Intersection ID: 9228	Main Street: FAIRMONT_ST	Cross Street: RENNER_ST	Location:	NW
ADA ID: 15520CCD4F8B	Ramp Type: Perp	Initial Pass/Fail: Fail	Overall Compliance: No	Severity Score: 12.5

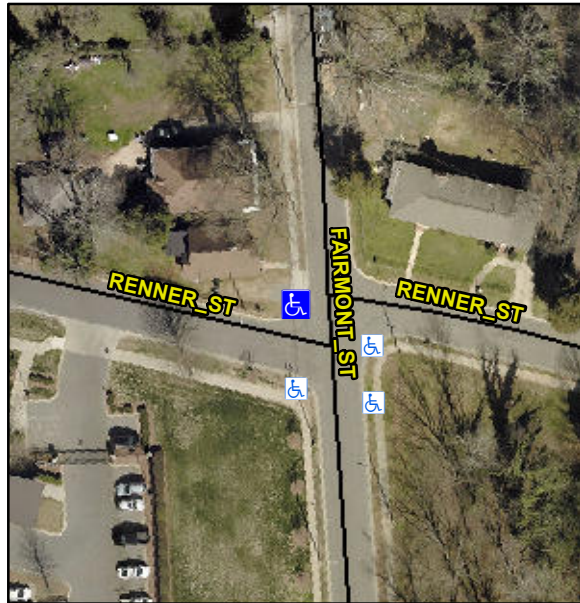
Not Found, R304.5.3

Compliance	Description	Data	Compliance	Description	Data
N/A	Ramp Length (in)	26.5	Yes	Ramp Slope (%)	7.5
Yes	Ramp Width (in)	48.0	No	Ramp XSlope (%)	5.8
N/A	Flare Type LT	N/A	N/A	Flare Type RT	N/A
N/A	Flare Slope LT (%)	N/A	N/A	Flare Slope RT (%)	N/A
N/A	Flare Traversable LT?	N/A	N/A	Flare Traversable RT?	N/A
N/A	Landing Length (in)	N/A	N/A	DWS Provided?	N/A
N/A	Landing Width (in)	N/A	N/A	DWS Contrast?	N/A
N/A	Landing Slope (%)	N/A	N/A	DWS Length (in)	N/A
N/A	Landing X Slope (%)	N/A	N/A	DWS Full Width?	N/A
N/A	Landing Curb? (Y/N)	N/A	N/A	DWS Offset (in)	N/A
N/A	Shared Landing?	N/A			
N/A	Gutter Ponding?	N/A	N/A	Gutter Slope (%)	N/A
N/A	Gutter Lip Ht (in)	N/A	N/A	Gutter X Slope (%)	N/A
N/A	Painted X Walk1?	No	N/A	Painted X Walk2?	N/A
	X Walk 1 Direction	To S		X Walk 2 Direction	N/A
N/A	X Walk 1 Width (in)	N/A	N/A	X Walk 2 Width (in)	N/A
	X Walk 1 Slope (%)	2.4		X Walk 2 Slope (%)	N/A
	X Walk 1 X Slope (%)	4.7		X Walk 2 X Slope (%)	N/A

Remove & Replace Entire Ramp.
